KANSAS GEOLOGICAL SURVEY

RE: Proposed Project of the City of Ingalls for Application to the Kansas Department of Health and Environment for the Kansas Public Water Supply Loan Fund for installation of a water supply well in Dakota aquifer and connection to the public water-supply system, and plugging of Well #1

Agency Review Comments:

Re: City of Ingalls
Kansas Public Water Supply Loan Fund
City Well # 4 Project # 2356

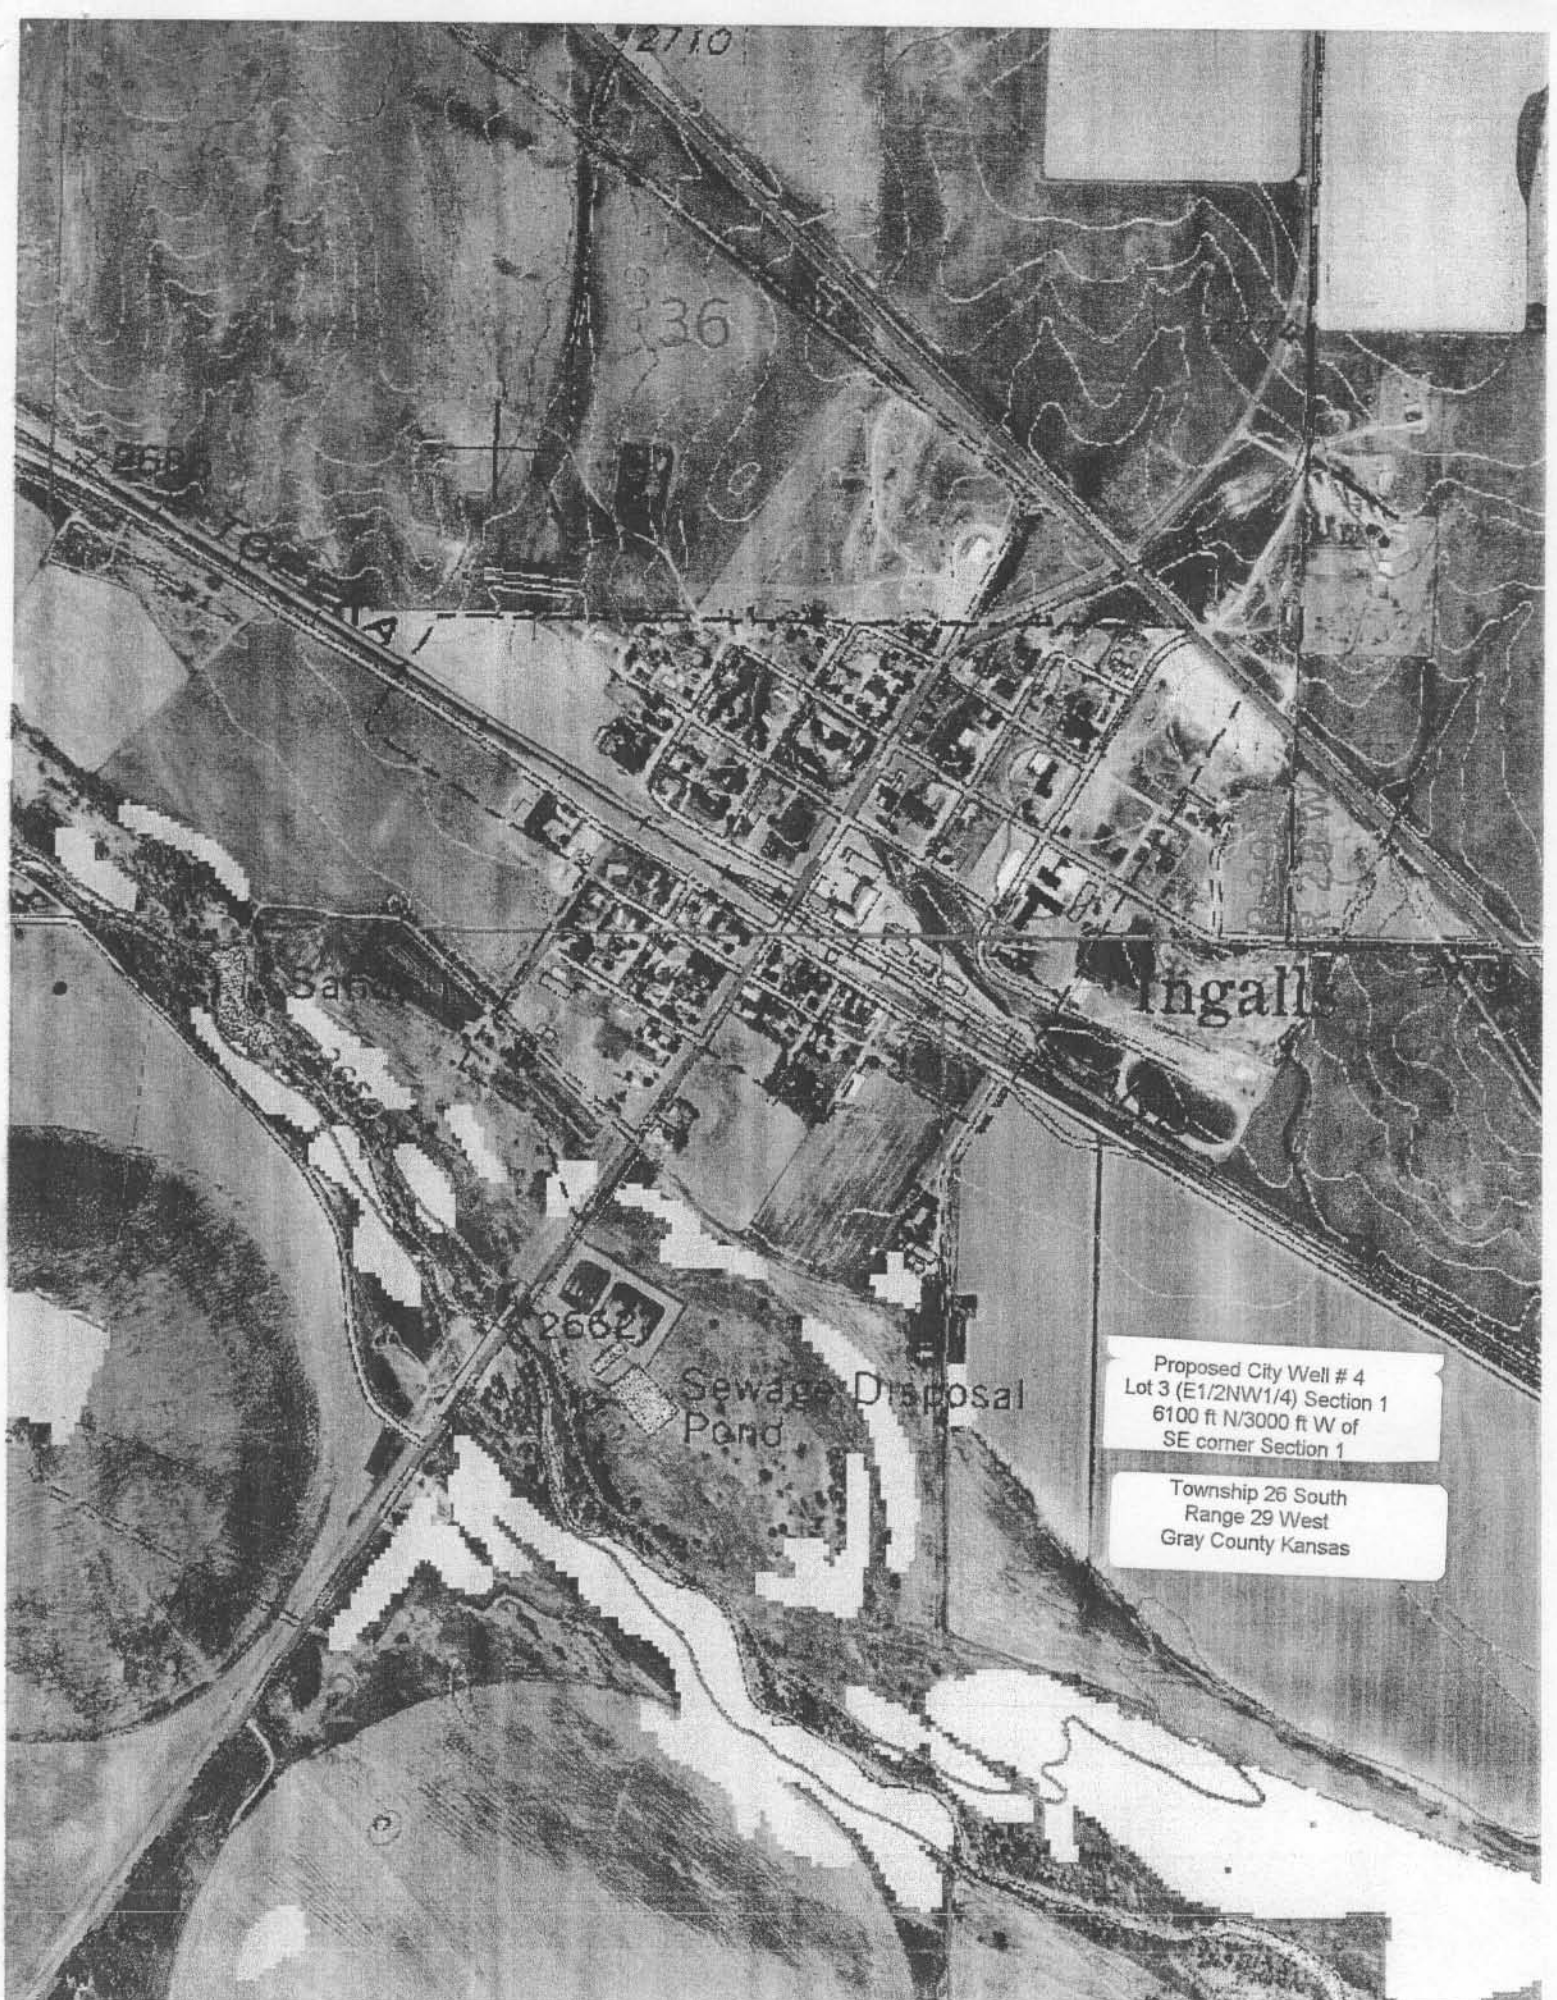
My concern was that the information originally sent did not indicate whether the public water supply well to be installed in the Dakota aquifer would be sealed from potential contamination from the overlying Ogallala-High Plains aquifer. Saline water from the Arkansas River, when it flows past Ingalls, seeps into the alluvial aquifer and then into the underlying Ogallala-High Plains aquifer. As you indicated, the Ogallala-High Plains aquifer in the vicinity of Ingalls also contains high nitrate concentrations that have slightly exceeded the drinking-water standard in the new Well #3 in the Ogallala. The saline and high nitrate ground water could potentially flow down the annular space between the borehole and the casing of the proposed Dakota well if there was sand or gravel placed in the annulus from above the well screen up through the lower part of the Ogallala-High Plains aquifer. The original information sent to me did not include the complete schematic for the proposed well. The diagram for the proposed well construction that both you and Mr. Vincent faxed to me show that bentonite holeplug is to be placed above the gravel pack in the annular space followed by a cement and sand mixture. The seal of cement, sand, and bentonite will occupy a depth interval of 50 ft across the top of the Dakota strata. Mr. Vincent said that there was shale in the interval of Dakota strata along which the annular seal is to be placed. This should provide good protection of the Dakota aquifer water to be pumped from proposed Well #4 from overlying contaminated ground water.
